V2500-A1 SERIES PROPULSION SYSTEM SERVICE BULLETIN

V2500-ENG-72-0476

ENGINE – HP COMPRESSOR DISCS (STAGES 3–8) – INTRODUCTION OF A DISC ASSEMBLY WITH
REVISED MATERIAL STAGES 6 TO 8

HP Compressor Stage 3-8 Disc Assembly Family Tree
Chart 1

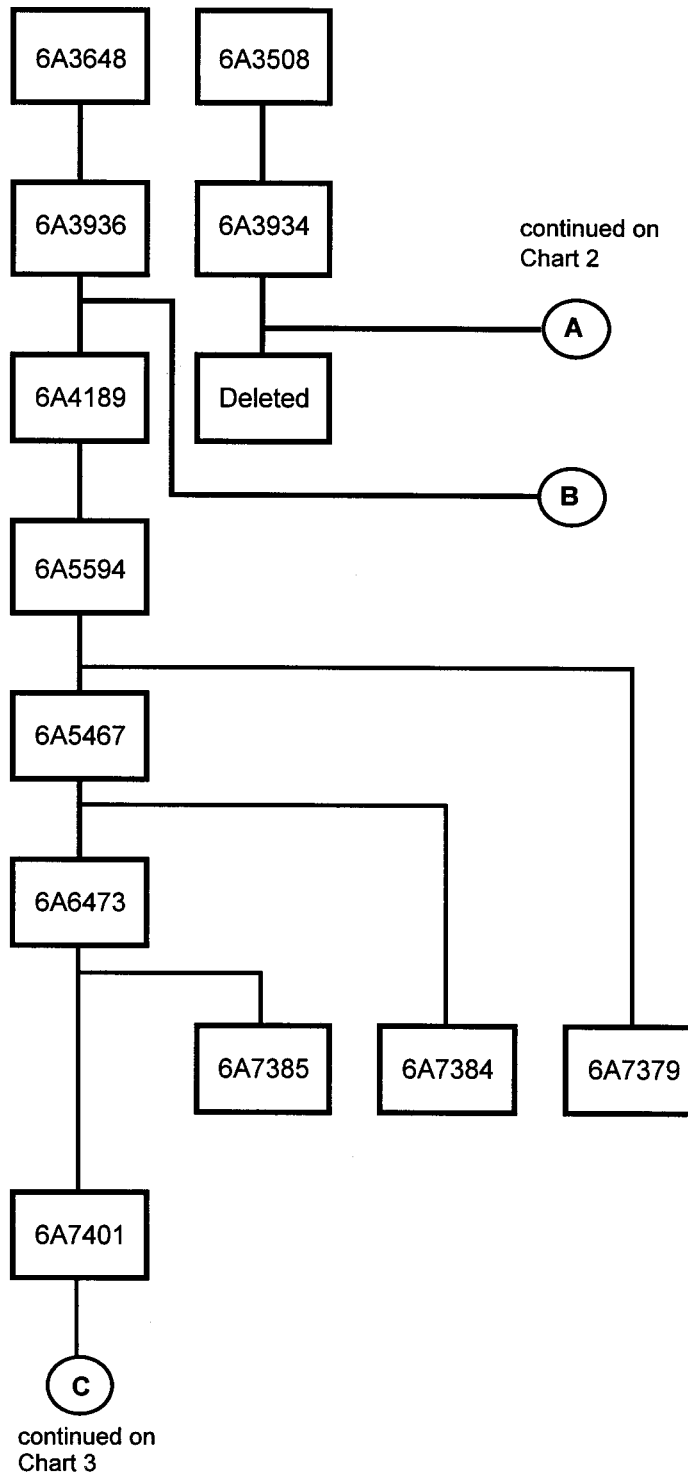
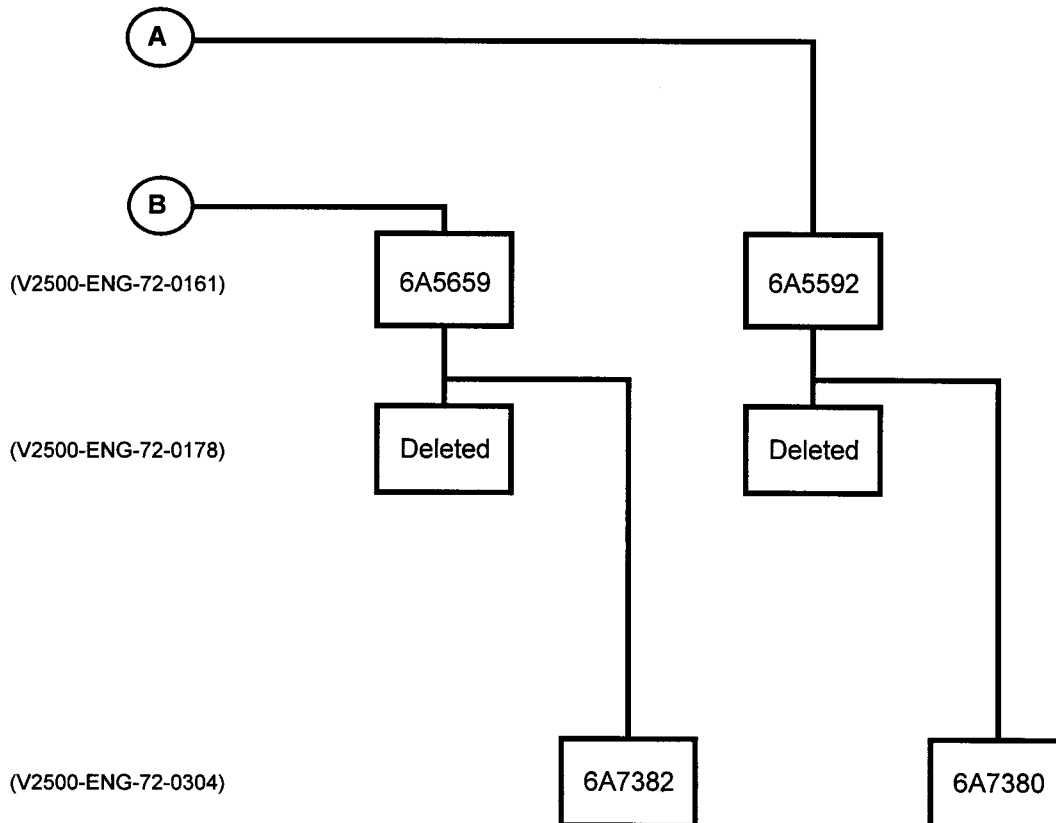
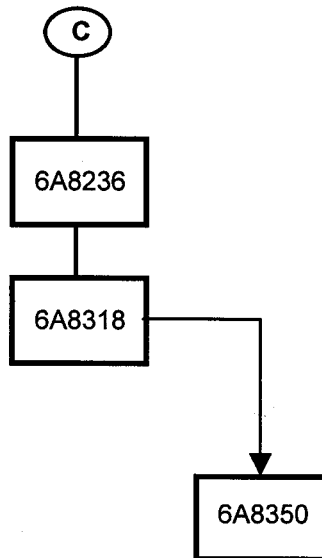
V2500-ENG-72-0476
HP Compressor Discs
Stages 3-8 - Intro of a Revised
Disc Assy with TDX Material
